Agenda Item	<b>6.11</b>
Report No	<b>PLN/025/19</b>

## THE HIGHLAND COUNCIL

**Report Title:** 18/05564/FUL: Diageo  
Land 195M SE of Talisker Distillery, Carbost

**Description:** Alterations and extension to existing distillery visitor centre car park

**PROPOSED SITE PLAN**

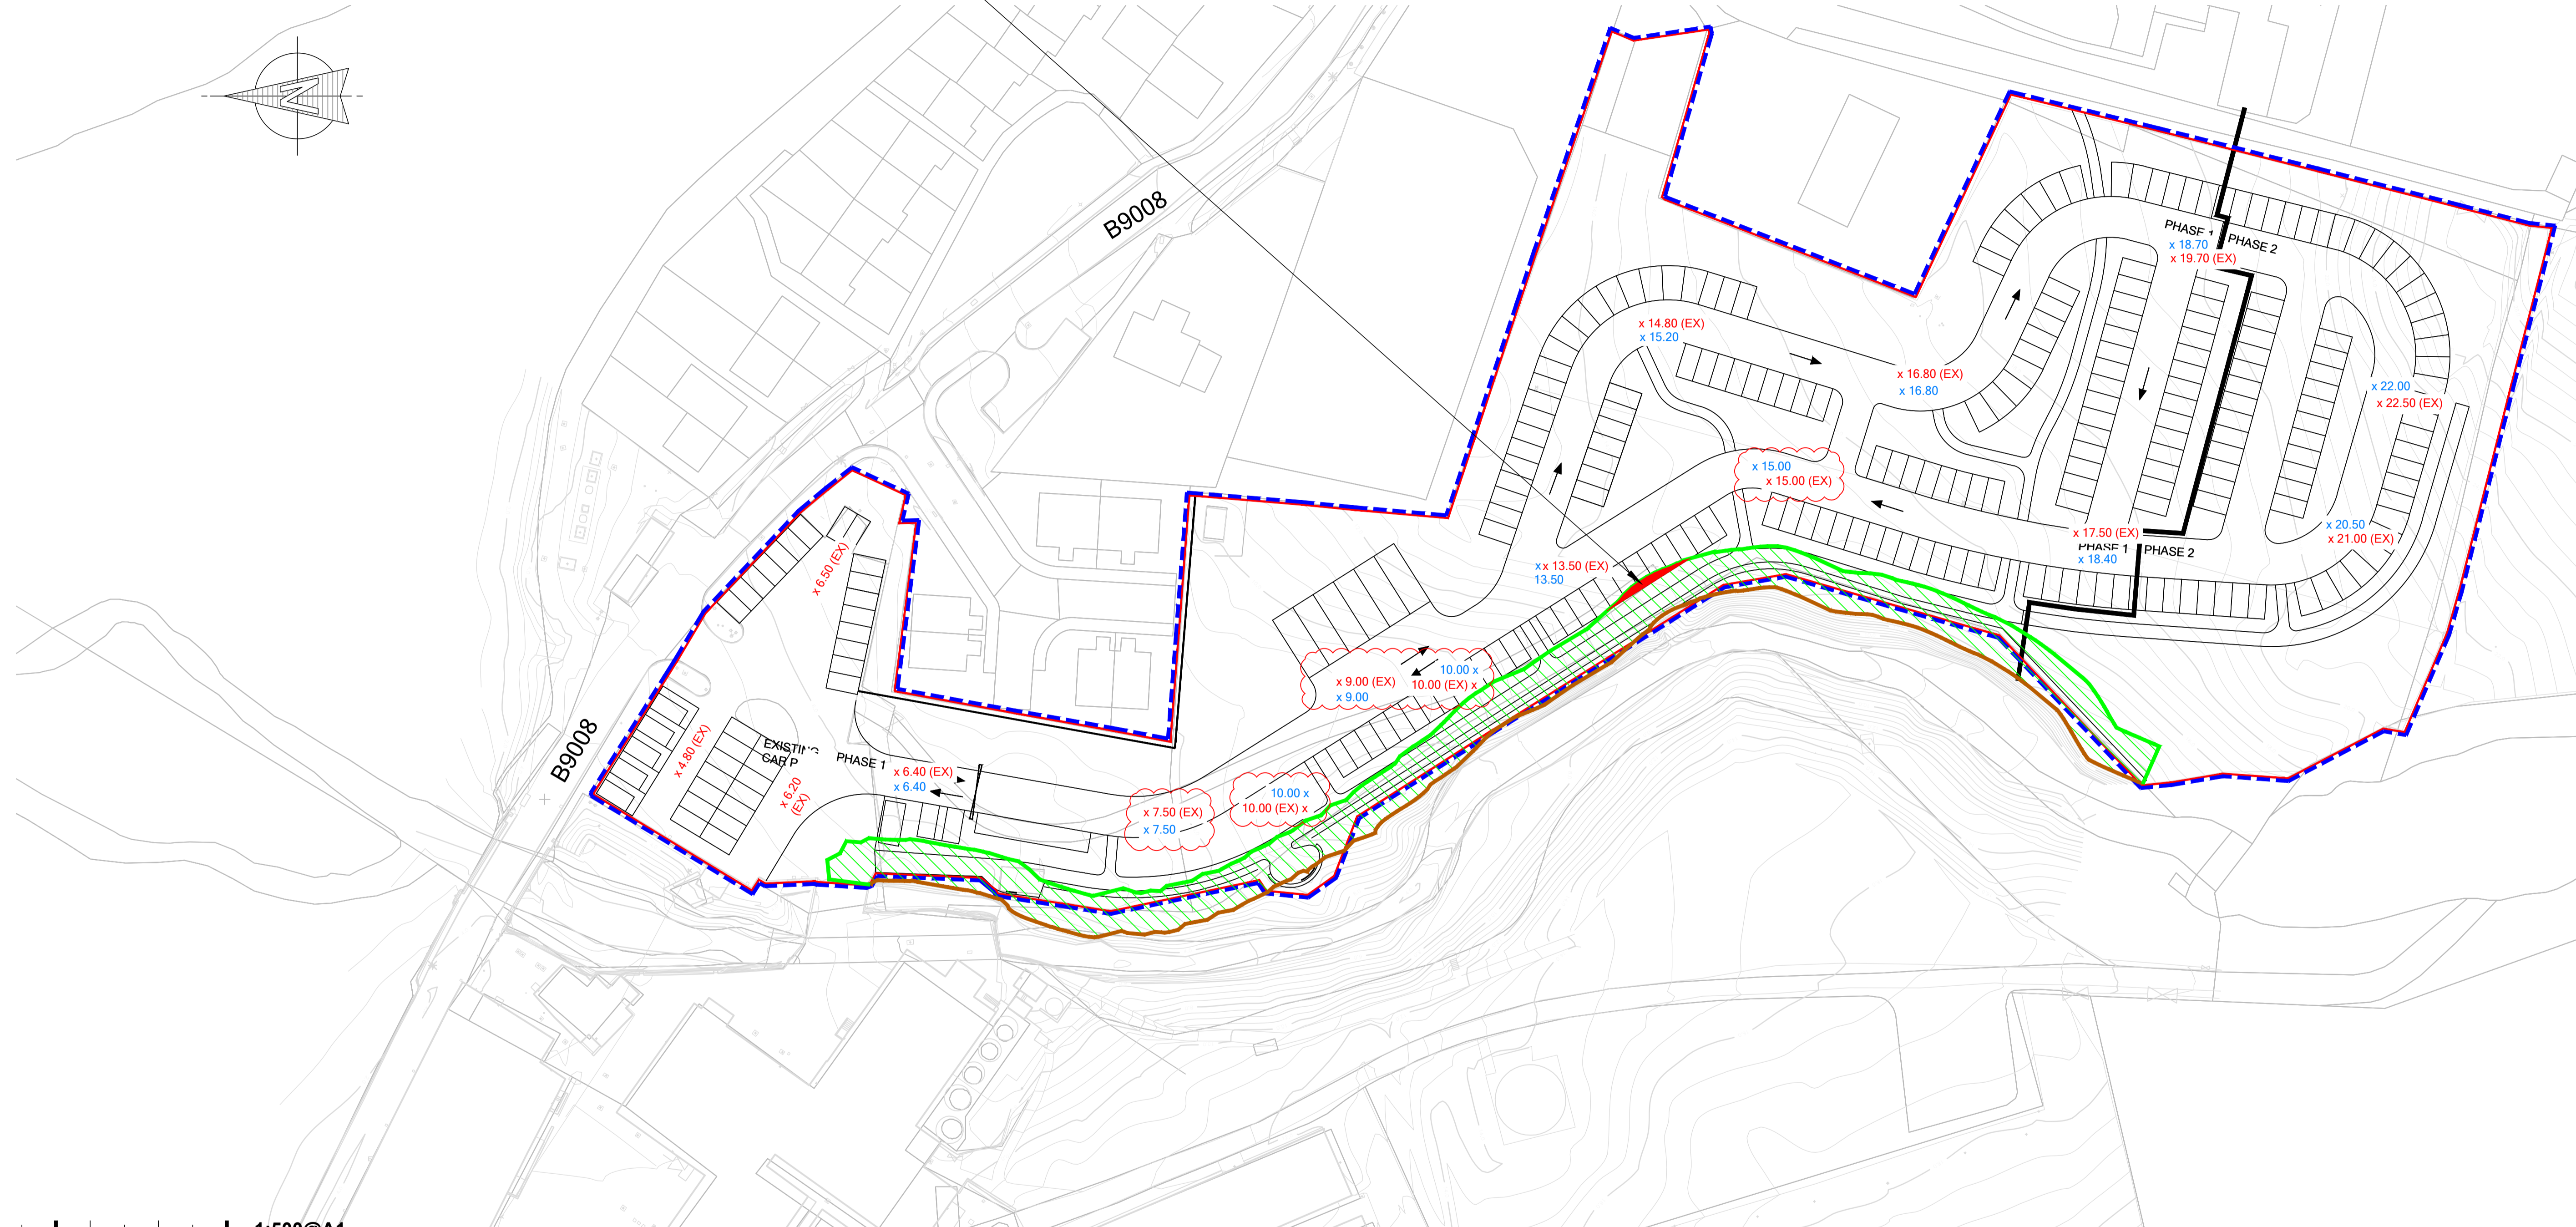
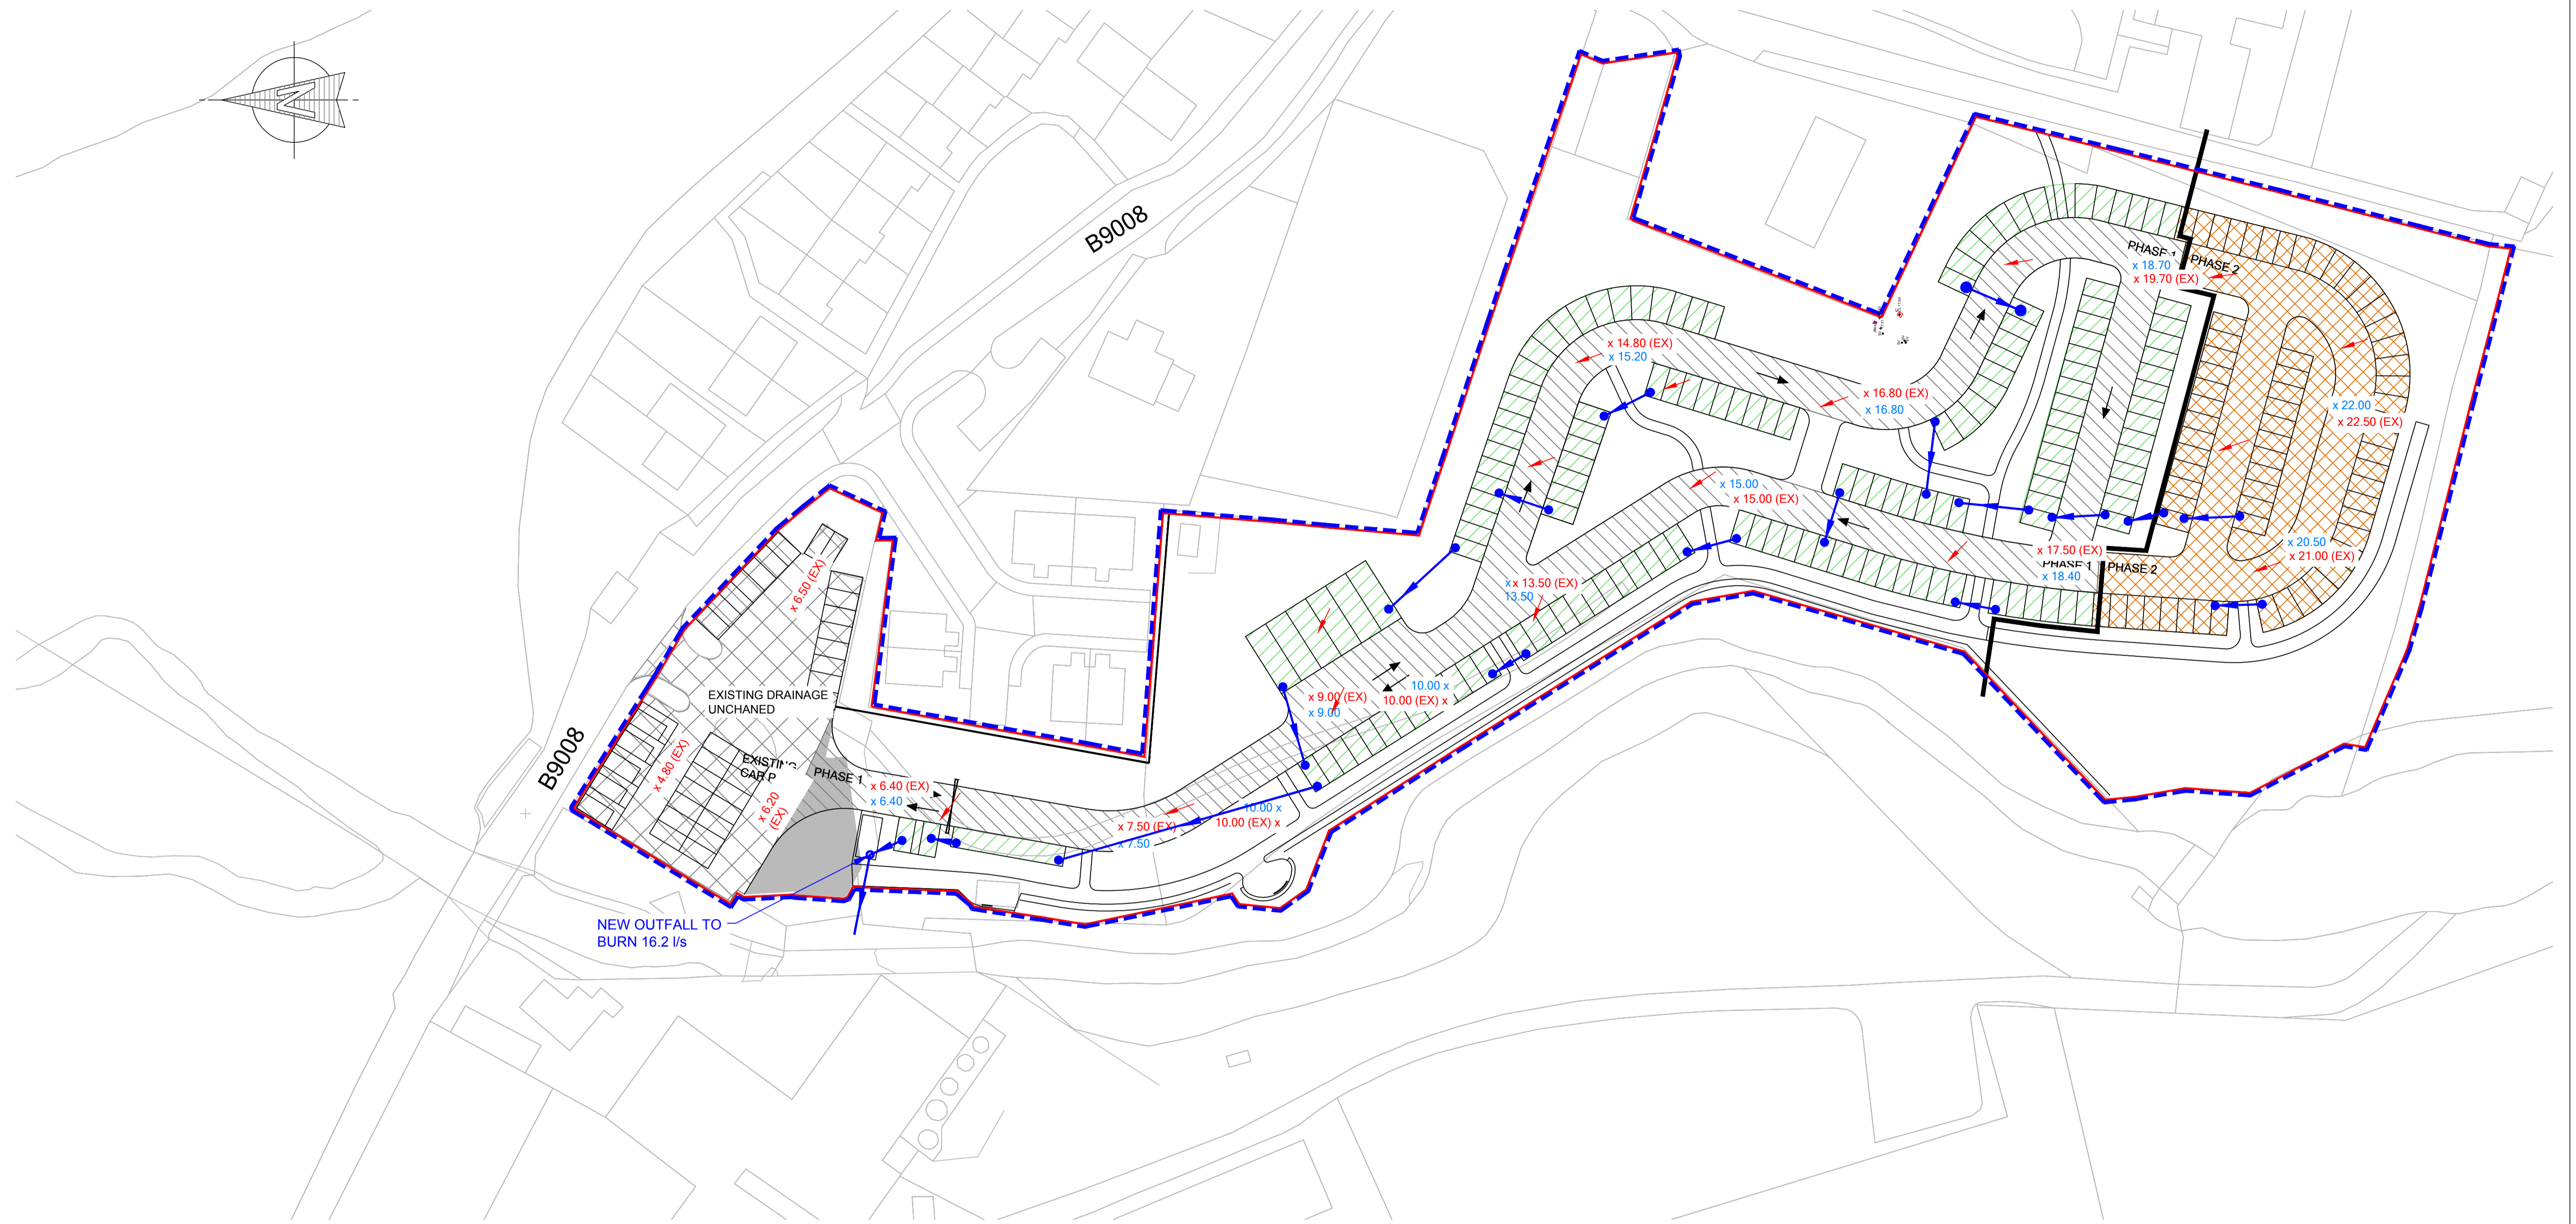
Further comments 13.02.2019 - No objection subject to conditions that no ground raising takes place in any of the areas identified as being located within the functional floodplain and a 6m buffer measured from the top of the bank of the watercourse should be kept free from all development.

5.5 SEPA: Initial response 19.12.2018 object on the grounds of lack of information. Second response 12.02.2019 No objection condition required to ensure that no landraising within the functional flood plan as shown on submitted plan is applied

- 8.11 The developer requirements associated of the current development plan allocation for the site set out the need for a flood risk assessment to be undertaken given the proximity of the Carbost Burn and coastal waters. SEPA and the flood risk management team have reviewed the assessment submitted by the applicant and have confirmed that they have no objections to the proposals provided that conditions are attached which secure that there will be no ground raising in those areas of the site which are identified as being located within the functional floodplain. These areas are the existing car park and where the access road will be routed from the existing car park past the rear of the properties of Pairc Uilleim. A condition is also required to maintain a 6m buffer strip from the top of the Carbost Burn embankment free from any development other than in one section along the embankment where a limited number of the car parking bays will encroach. These details are contained within the revised drainage layout plan which has been considered by consultees and third parties.

6. There shall be no landraising within the functional flood plane and a 6m buffer shall be maintained with the Carbost Burn all as shown on Drawing AZ70796:00:003A "Proposed Site Plan".

PROJECT: TALISKER DISTILLERY  
 ARCHITECT: MICHAEL LARD ARCHITECTS  
 TITLE: ELECTRICAL SERVICES CAR PARK LIGHTING SITE PLAN

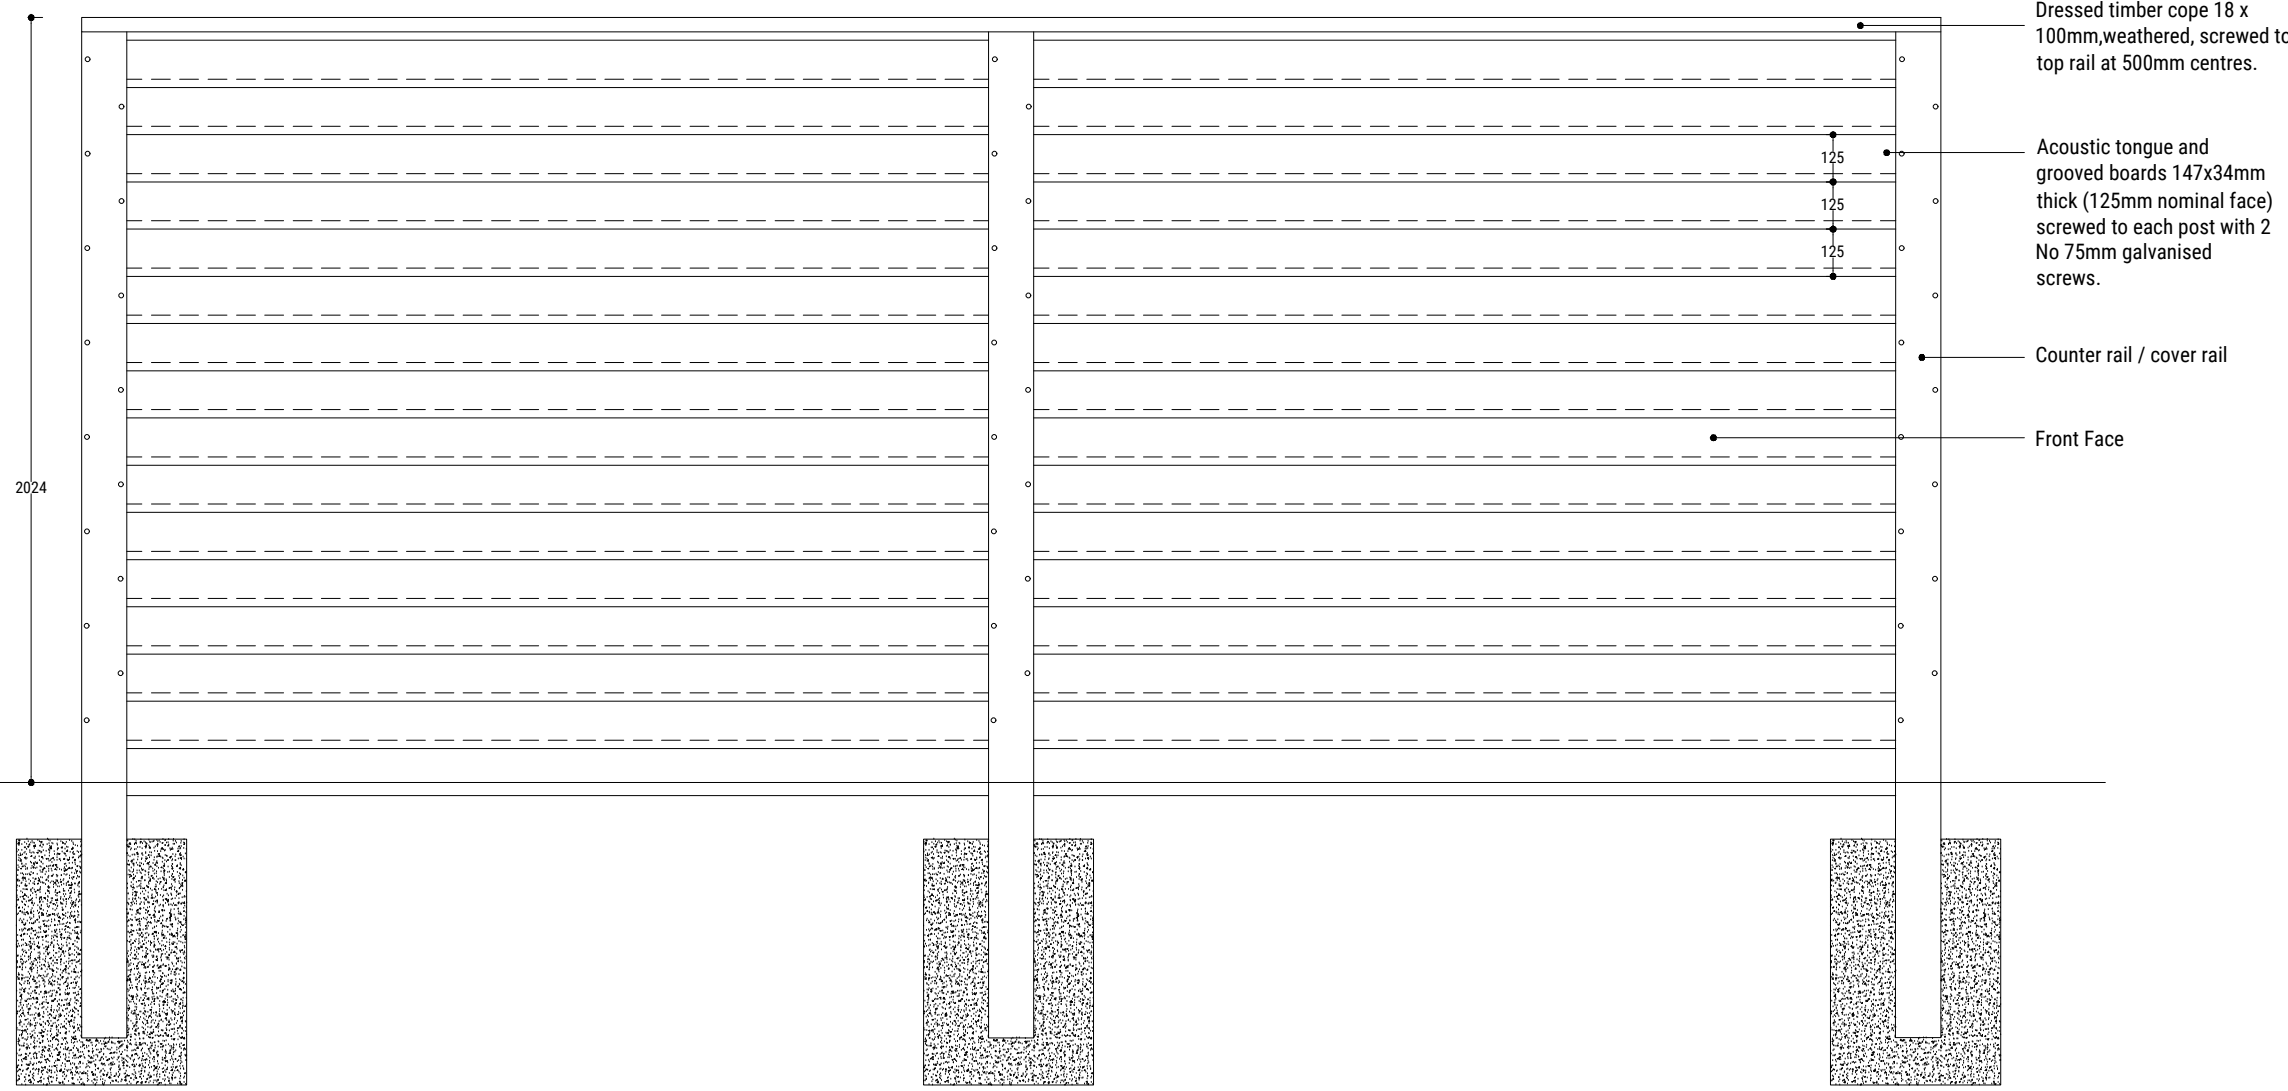
- 1.2 Low-level lighting columns are proposed. The lighting will only be operational during visitor centre hours which are as follows:
- January - March: 10:00 - 16:30  
April - June: 09:30 - 17:00  
July - August: 09:30 - 17:30  
September - October 09:30 - 17:00  
November - December 10:00 - 16:30

3. The lighting system shall be fitted with an automatic cut-out timer to ensure that the system cannot operate outwith the following operational hours of the visitors centre:

drawing 2M ACOUSTIC FENCE

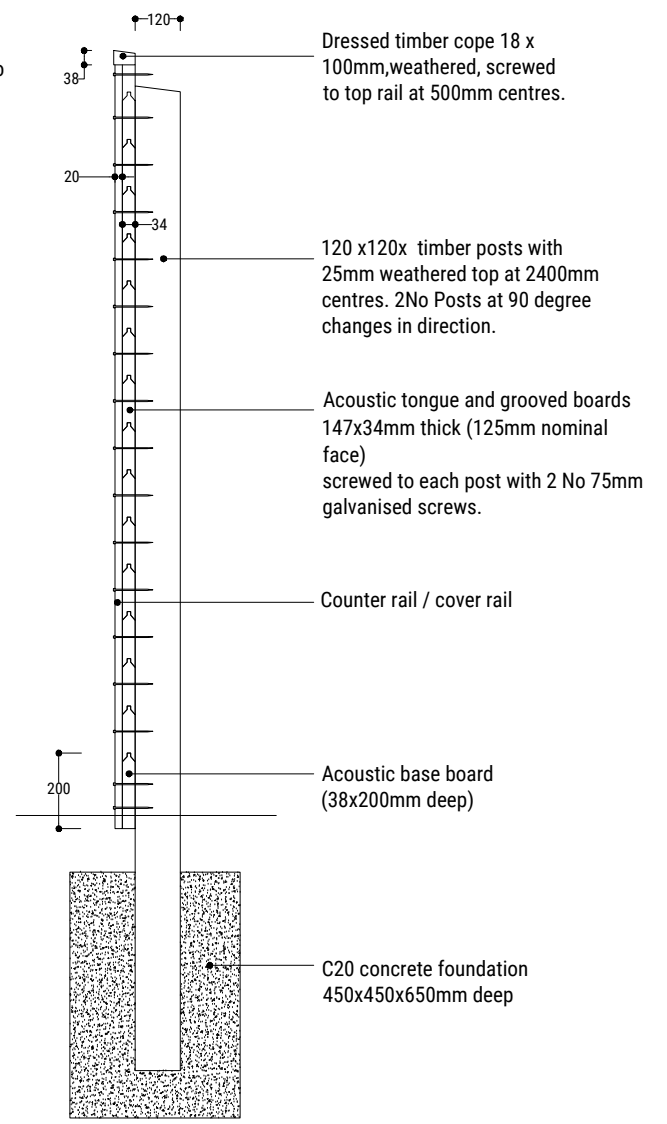
c) access strip should be maintained between boundary with Pairc Uilleim and acoustic fence to allow maintenance.

d) acoustic fencing should be erected prior to any construction taking place.

it is also proposed to construct a 2m high acoustic fence along the rear and side boundaries of these properties. Acoustic fencing is specifically designed to protect noise sensitive premises from noise pollution. Visually, it has little greater impact than standard garden fence. At its closest, it will be about 4m from the rear and side elevations of nos. 2, 3, 4 and 5. Between the parking spaces and the acoustic fencing landscaping is to be introduced which will combine earth bunding and tree planting. The applicant has also confirmed that the gravel proposed for the parking bays will be contained within a honeycomb membrane which stabilises the gravel and prevents it from dispersing, which might otherwise cause dust. It is considered that these mitigation measures will reduce adverse effects of the development on the residential amenity of these properties to an acceptable level.

1. No development, site excavation or ground works shall commence until a construction management plan has been submitted to and agreed in writing by the Planning Authority. Thereafter the development shall be undertaken in accordance with the approved details. Detail within the plan shall address the following matters:
  - measures to control construction-related dust.
  - measures to control construction- related mud being brought onto the public road.
  - measures to control the movement of heavy goods vehicles to avoid all nearby school opening and finishing times.
  - details of the site construction compound and staff parking.
  - a phasing plan for the construction of the acoustic fencing
